plan of
Staging Plan (17 Lots Stages 7A-7E)

RRC Ref: D/37-2017_one lot into 18 Stages 7(A B & C)
Our Ref: 1096_Response to ROL Information Request

D/37-2017, ROL APPLICATION, 1 LOT INTO 18 LOTS Lot 253 & LOT 254 SP241210 – EDENBROOK STAGE 7 (A, B & C)

We acknowledge on behalf of the Applicant receipt of Council's letter dated 4 April 2017 wherein further information is requested. The Applicant has approved the following response:

|  | |  | | DRAWING NUMBER 1097-FM01 | ISSUE SHEET NO 2 1 |

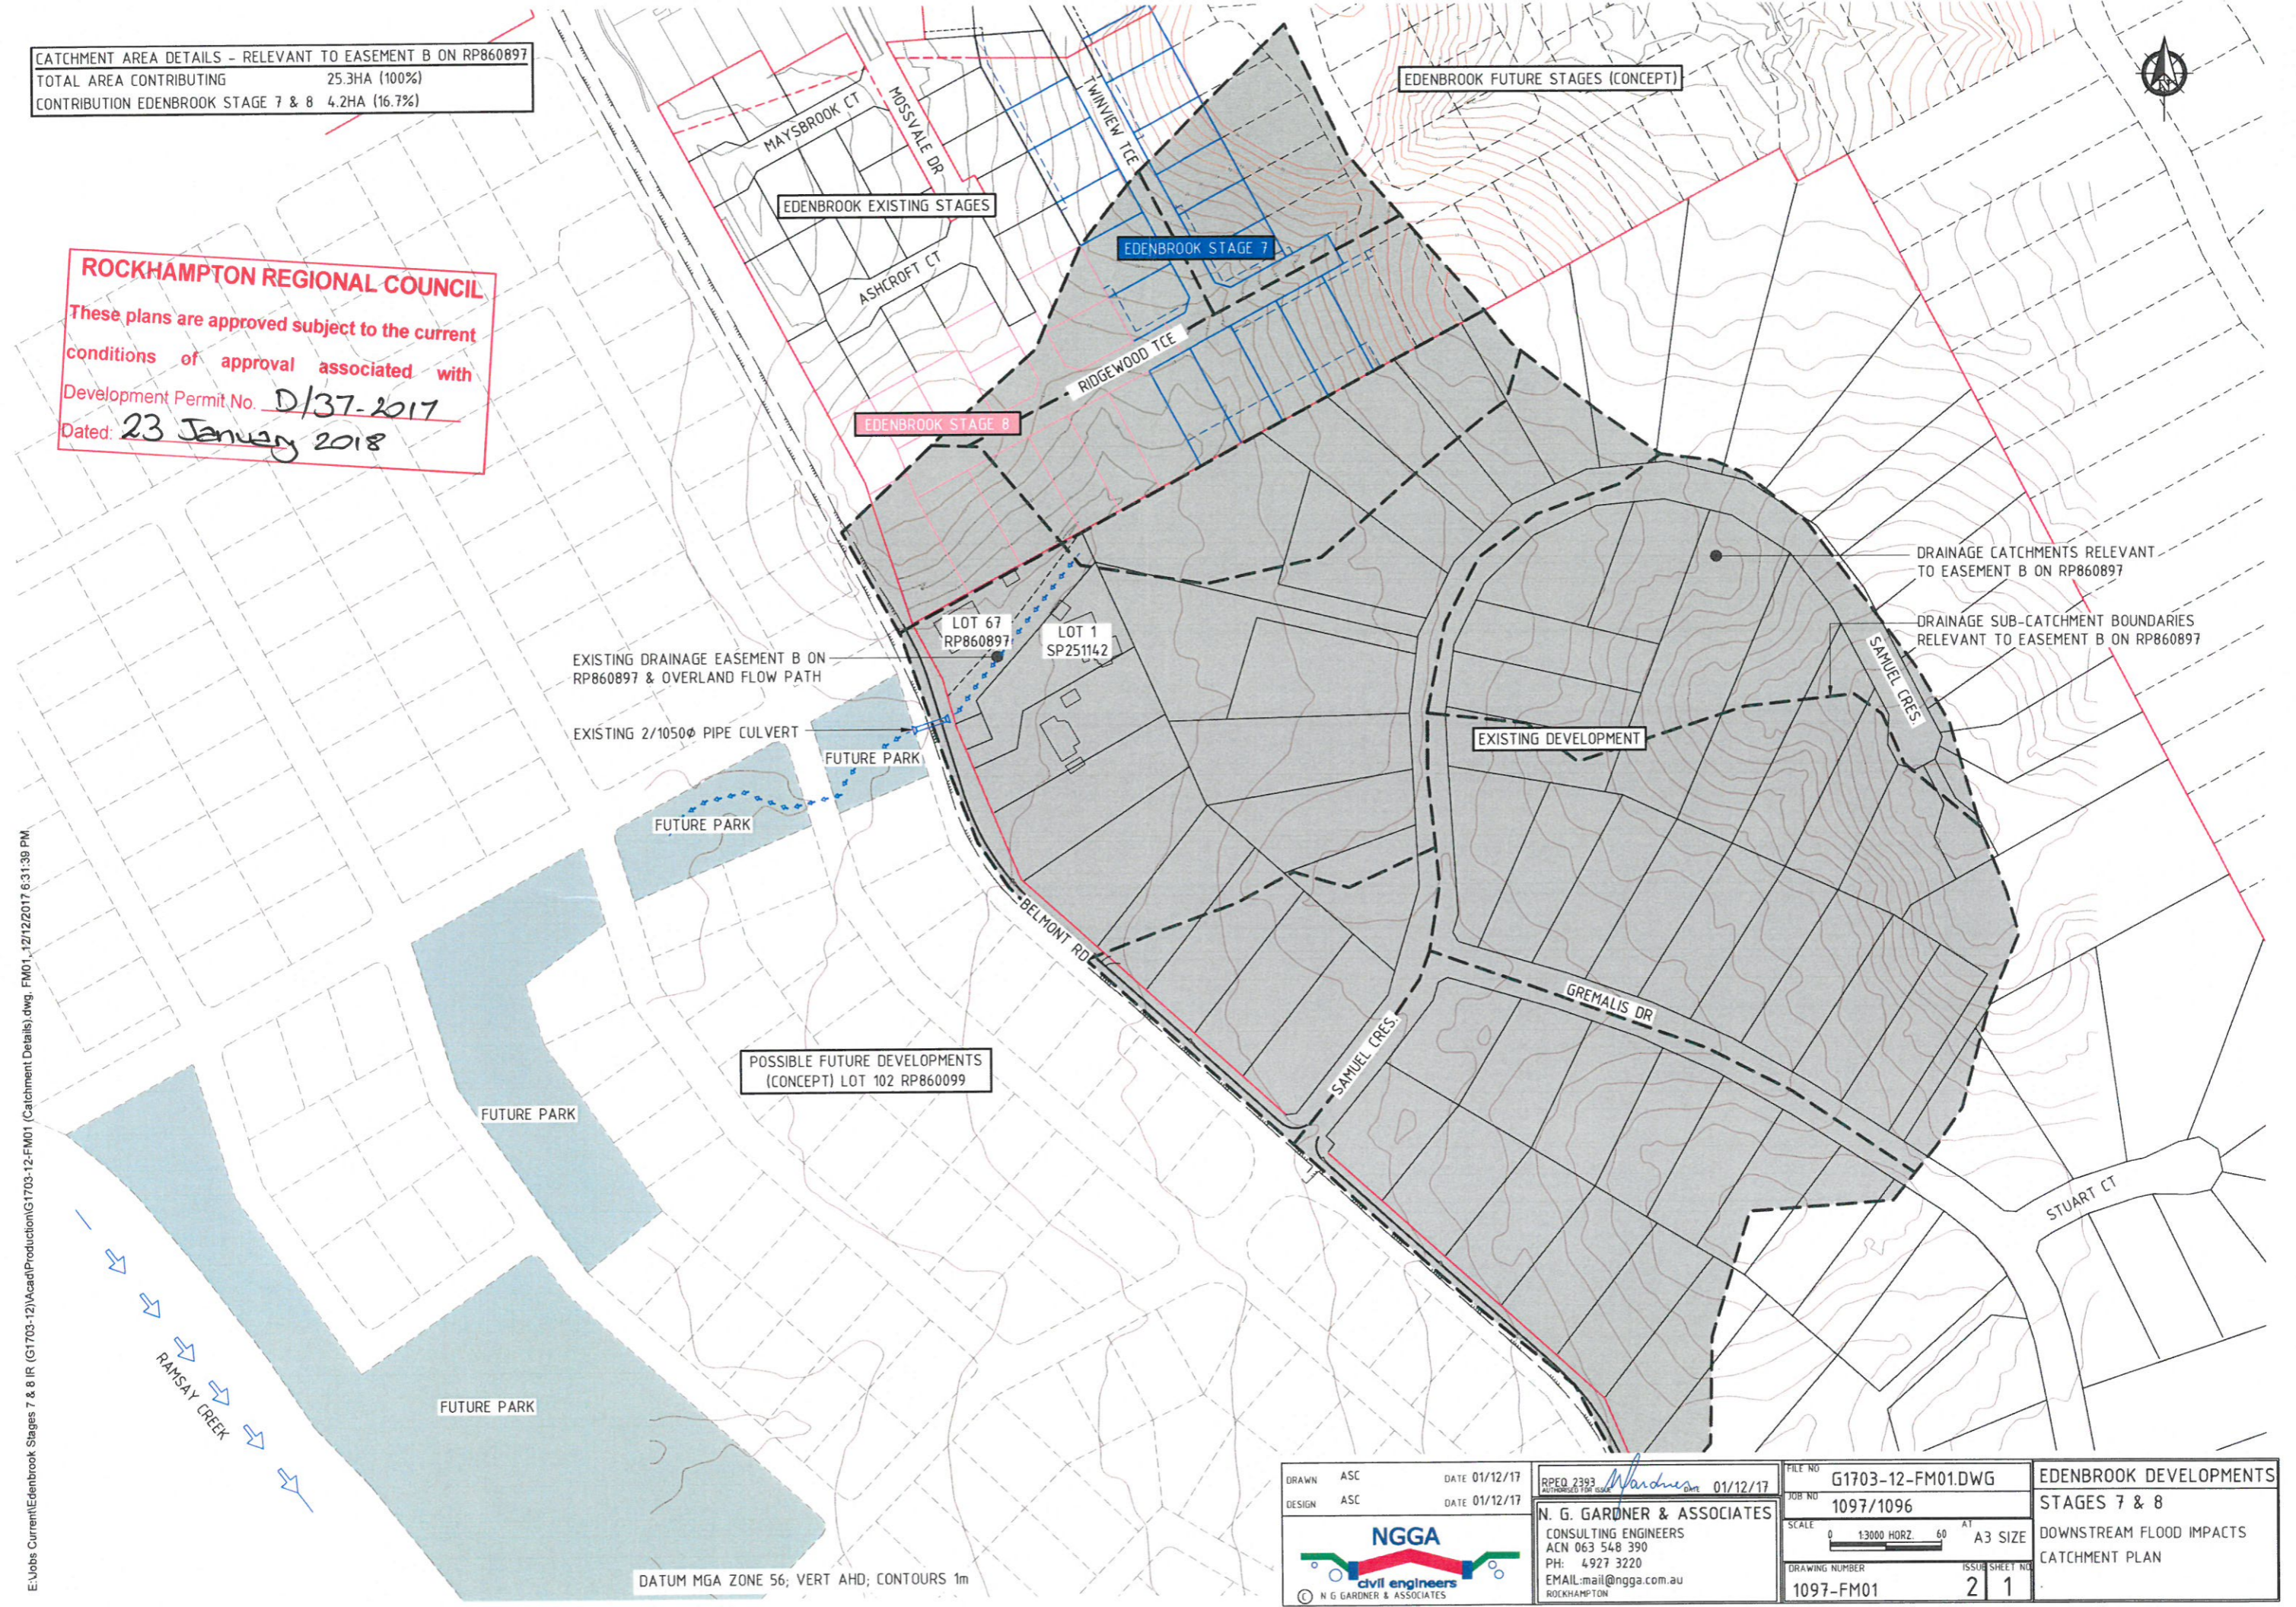
1.1 A portion of the subject development site drains to the south through an existing easement adjacent to Lot 67 on RP860897 (97 Belmont Road, Parkhurst). The applicant has stated that they accept that Council will impose a condition to reach an agreement with the neighbouring property owners to adjust this easement to accommodate the stormwater flows from the subject development; however it is appropriate that these negotiations occur as part of the subject application. The submitted documentation does not propose any mitigation measures to limit the peak flows from the site to that of the pre-development scenario and Council is concerned that the existing downstream drainage infrastructure may not be sufficiently sized to accommodate the additional runoff from both the subject development, and the future stages that will also be directed through this easement.

Supporting pre / post development calculations and flow path cross sections demonstrating the appropriateness of the proposed drainage arrangement, as well as any required agreement from the affected downstream property owners, must be submitted to Council prior to any approvals being granted. Please amend the application accordingly to address these matters.

Drawing 1097-FM01 - Catchment Plan including the approved layout west of Belmont Rd.

The overall catchment with sub-catchments is shown on Drawing No 1097-FM01.

The relevant portion of the catchment within Edenbrook is 4.2 hectares and this represents 16.7% or one sixth (1/6) of this overall catchment of 25.3 hectares.
